CENTER for SCIENCE in PUBLIC PARTICIPATION

October 26, 2020

Stibnite Gold Project

Scope of Review

Figure 5. Surface samples. Yellow squares highlight where groups of samples were collected, numbers refer to the number of samples collected at each site. *Source: SRK 2017 Baseline Geochem Fig. 3-4*

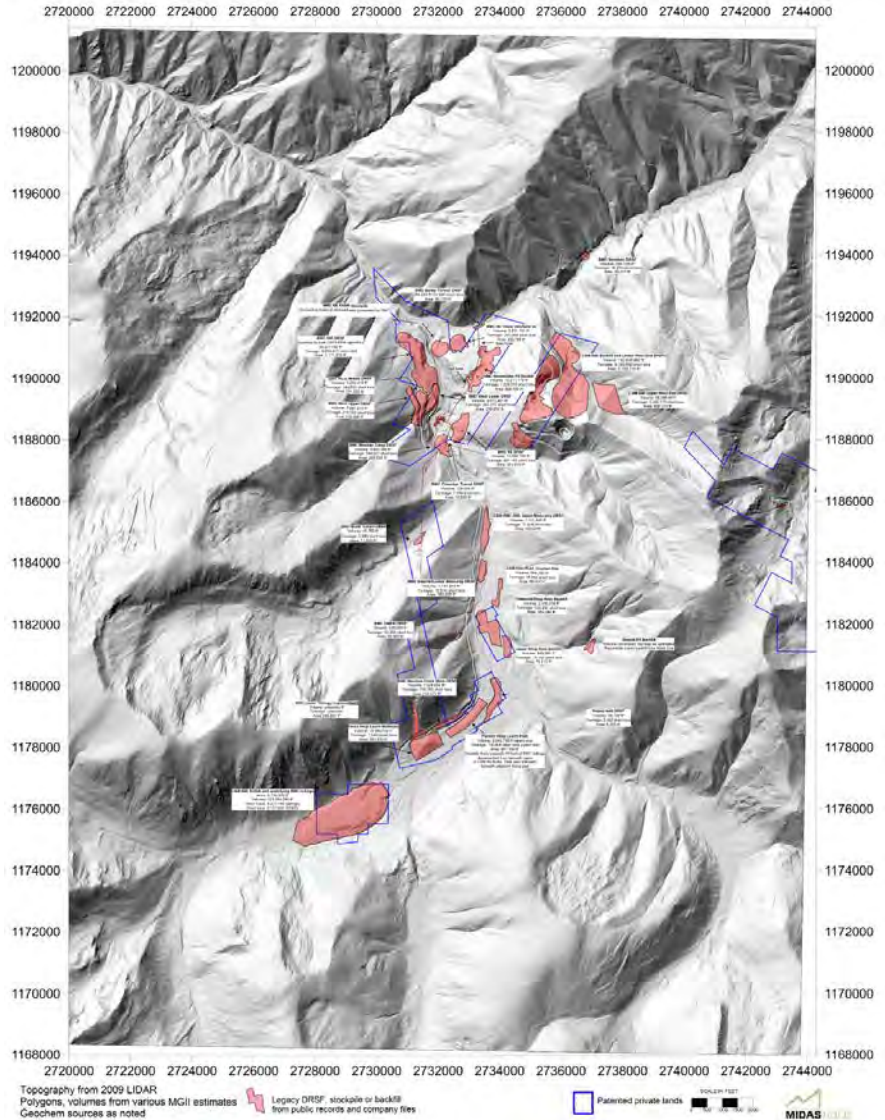
- A map of all sample locations, including those from fresh core drilling, relative to faults and historic and future mine facilities, is needed to determine if sampling was spatially adequate. Phase 2 sampling was designed to address data gaps in spatial and lithological representation. Phase 2 actually conducted tests on existing samples, expanding lithological representation without expanding the spatial representation.

Figure 6. Tailings tested for acid and neutralization potential. Source: SRK 2017a, Table 3-61

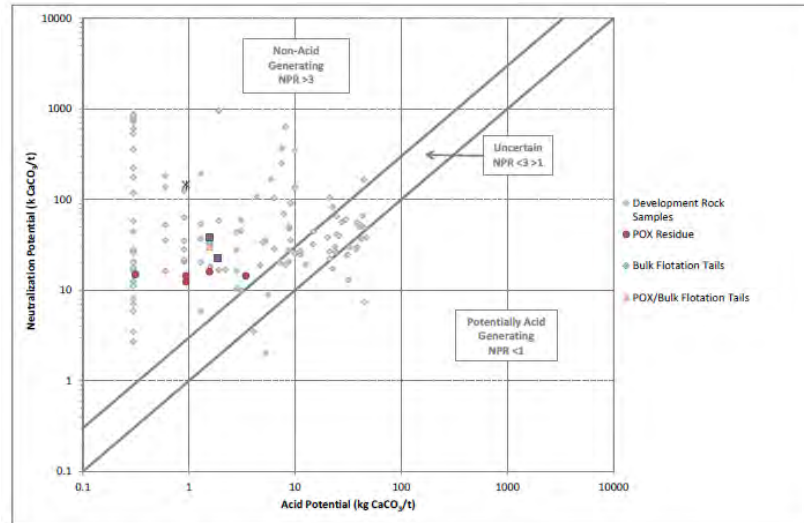
- Although six POX tailings samples went through SPLP, only a single sample of mixed POX and flotation tailings was tested by SPLP.
- Tailings leachate chemistry testing could be improved. Only SPLP tests were done due to a lack of material – why couldn't more material be made available? The MWMP has a liquid to solid ratio of 1:1 and is more representative of arid or semi-arid areas like the Stibnite site.

The tailings samples were submitted for SPLP leach testing, rather than MWMP, due to the limited quantity of tailings material available for testing and the finer grain size. Some of the disadvantages of the SPLP test are the high liquid to solid ratio (3:1) that may result in an underestimate of leachability and grain size reduction may increase reactivity. The MWMP and HCT leachate chemistry for the tailings and development rock is therefore not directly comparable. The SPLP results only provide a qualitative evaluation of constituents that could occur at concentrations above the water quality criteria and are not considered to be conclusive or to represent actual predictions of water quality.⁶⁶

Figure 7. Waste rock and ore acid and neutralization potential. Green dots show waste rock material chosen for HCTs; the black dot is an ore sample chosen. No surface samples were chosen. *Source: SRK 2017 baseline Fig. 3-8*

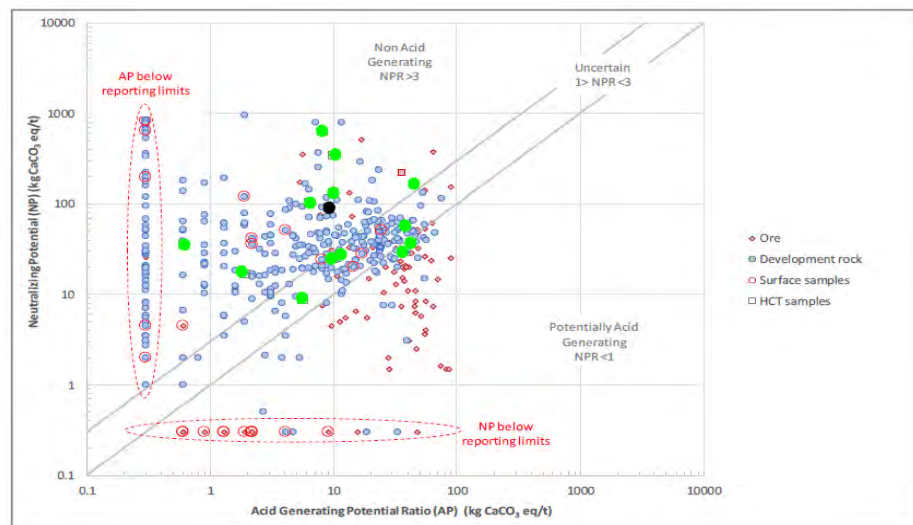
- Only a single sample of ore-grade material went through HCTs (Fig. 7). The ore-grade sample was chosen from non-acid generating material, when most ore-grade material falls in the potentially acid generating area. Including them in HCTs would provide information on the rates at which analytes may leach from this material, which will be present on pit walls, tunnels if underground mining occurs, and potentially in waste rock an tailings.

Figure 8. Model of future contaminant concentrations based on past precipitation. (Upper) Annual average precipitation data applied in predictive SWWC model. (Lower) Predicted future arsenic concentrations at HF WRF. *Source: SRK 2018c Fig 4-9, Fig 4-17, and others.*

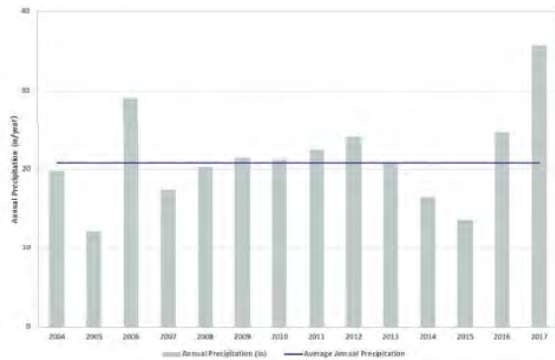
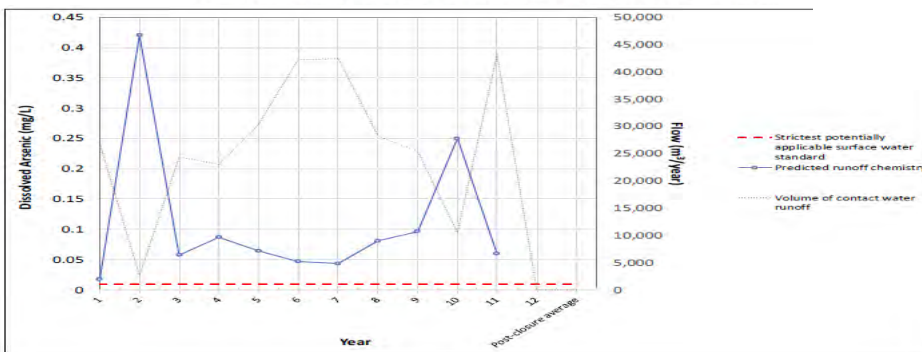
- Applying annual precipitation averages for years 2004-2017 directly to mining years provides insufficient results. As applied in the model, 2005 was a low water year, so predicted stream water quality in Mine Year 2 reflects a low water year (Fig. 8). This is inappropriate for understanding environmental impacts. Precipitation should be applied on a monthly or weekly basis and inform predictions for water quality at stream nodes on a monthly basis.

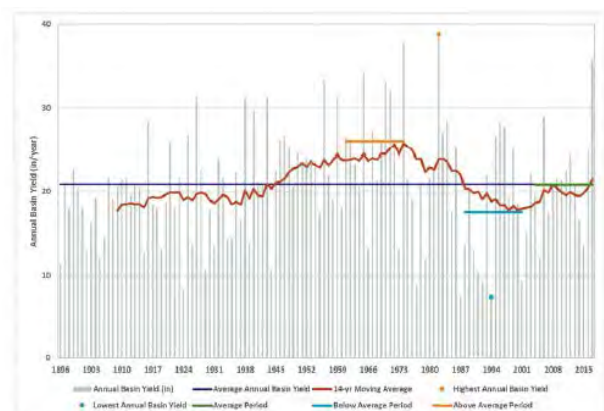
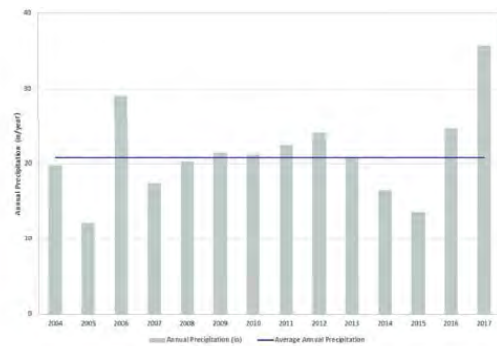
- A wider range of precipitation needs to be considered in bounding uncertainty (Fig. 10).
- There is uncertainty associated with future wildfires, and their effect on soil (soil chemistry, ability to hold moisture, slumping and landslides) and water quality (increase in mercury from air deposition and ash, turbidity, increased dissolved organic carbon concentrations in streams, which can change the bioavailability of certain metals, etc.). Wildfires may increase in frequency and intensity and this type of hazard is one reason why uncertainty analyses are necessary, to acknowledge that water quality is not going to neatly follow models, particularly when looking out 100 years or more and that in fact a wide range of natural changes may add or subtract from a wide range of reasonable model outcomes.
